TO BE CONSTRUCTED IN  
**TRACT NO. 30430**

**PRIVATE CONTRACT NO. 9404**

INDEX 273-5-129  
W.S. 62  
3 SHEETS, 5 PAGES

- REVISION NO. 1** 5/8/80
- PAGE 1 INDEX MAP REVISED TO SHOW NEW LIMITS FOR TRACT NO. 30430
- PAGE 2 DELETED SEWER OPEN CREST DRIVE BETWEEN STA. 25+51.89 AND 30+30.00.  
REVISED SEWER PLAN C PROFILE OPEN CREST DR. BETWEEN STA. 24+25 AND 25+43.89
- PAGE 3A DELETED SEWER IN BROCCUS PLACE.  
REVISED SEWER PLAN AND PROFILE GROVE-PARK DR. BETWEEN STA 0+00.00 AND 6+50.00, ALONG THE NORTH SIDE OF GROVE-PARK DR. DELETED LOTS 23 THRU 33 INCL. TR. 30430 AND REPLACED WITH LOTS 47 THRU 55 INCL. TRACT 30721.
- PAGE 3C REVISED SEWER PLAN AND PROFILE GROVE-PARK DR. BETWEEN STA. 0+00 AND 1+15.00.
- PAGE 4B DELETED SEWER IN MARJORAM COURT.
- PAGE 5 REVISED SEWER PLAN AND PROFILE GINGER WAY BETWEEN STA. 0+00 E. 2+72.10.  
DELETED SEWER BETWEEN STA 2+72.10 AND 6+50.00.  
APPROVED: *Ralph David Stewart 12/29/77*  
OFFICE OF COUNTY ENGINEER

48121

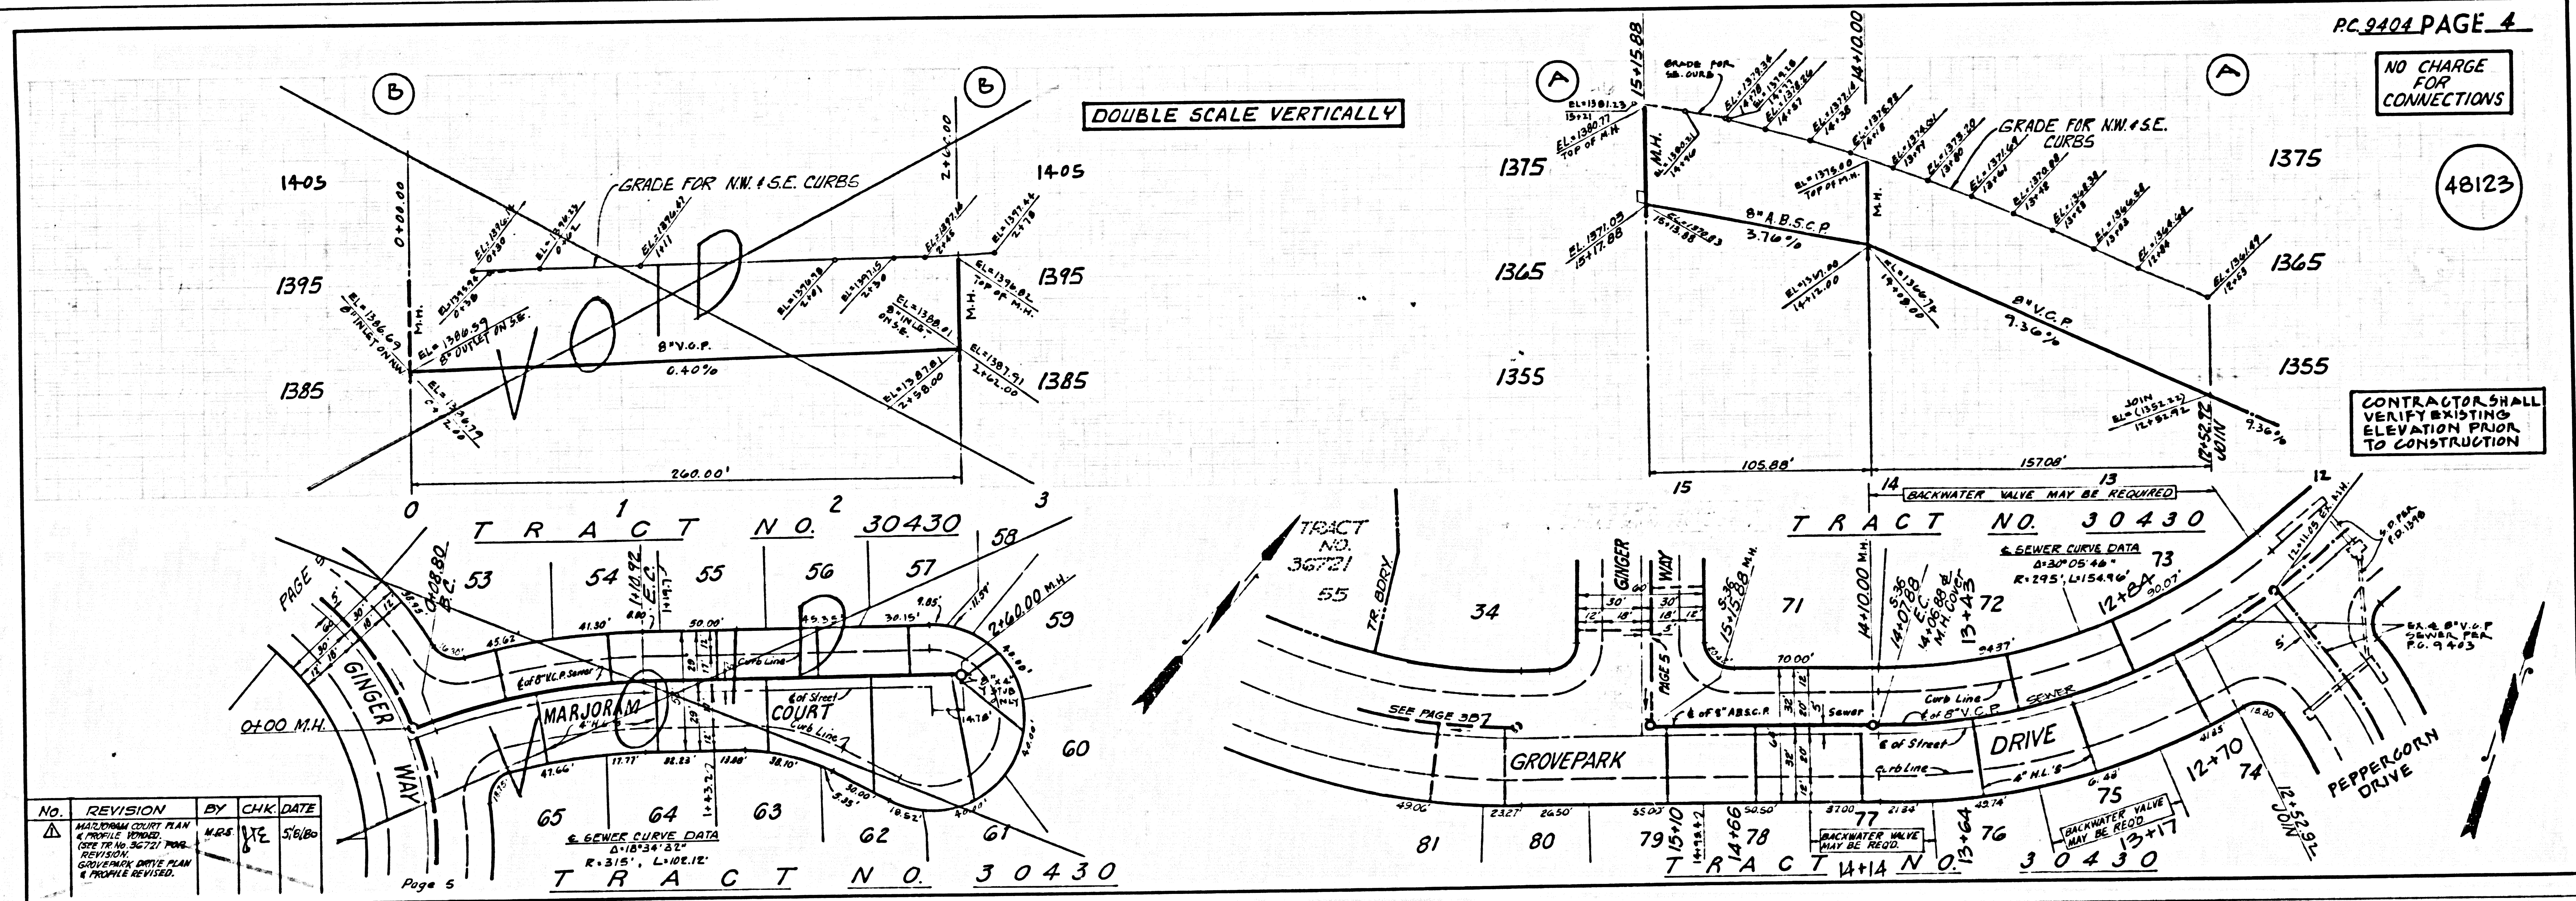
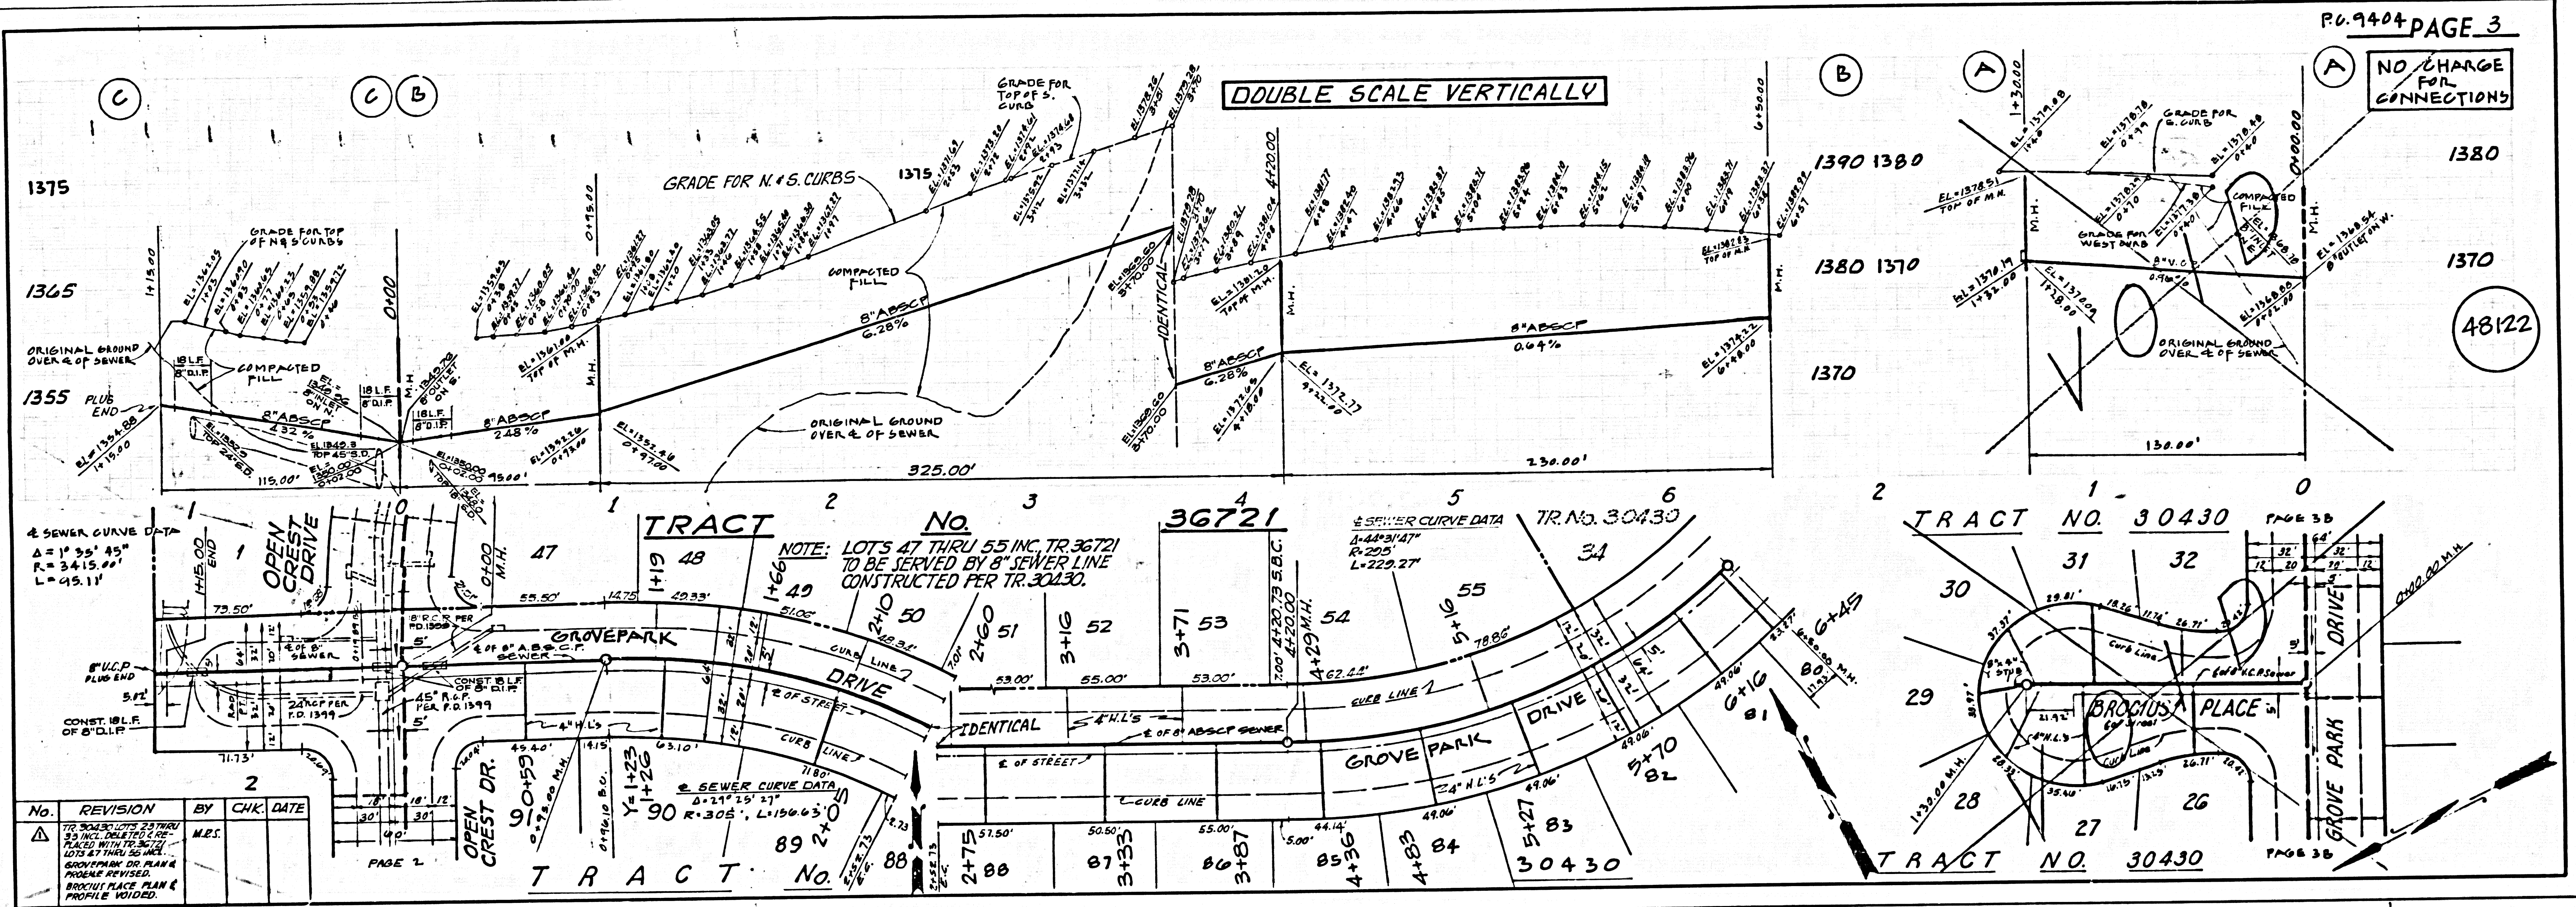
PORTION OF SEWER FROM STA. 24+25.00 TO STA. 25+43.89 TO BE BUILT PER TR. NO. 30430 CONTRACT.

No.	REVISION	BY	CHK	DATE
1	REVISED CONSTRUCTION PLAN AND PROFILE TO SHOW NEW LIMITS FOR TRACT NO. 30430	MRS. J.F.	FE	5/8/80
